PRODUCTS AFFECTED: C002S Shutter Camera		
CHANGE CATEGORY:		
☐ Material	☐ Process	☐ Package
☒ Design	☐ Data Sheet	☐ Packing/Shipping
☐ Other: Bill of Materials	☐ Other:

C002S Shutter Camera. The operation of the shutter function has been improved. Improvements in the monitor's power management and changes in the capacitor in the camera now allow the shutter to operate without the need for a separate power source at the camera.

Image of change:

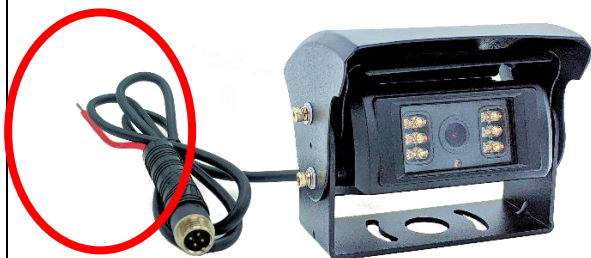
Old: needed power supplied at the camera.

New: No external power wire is required for the camera.
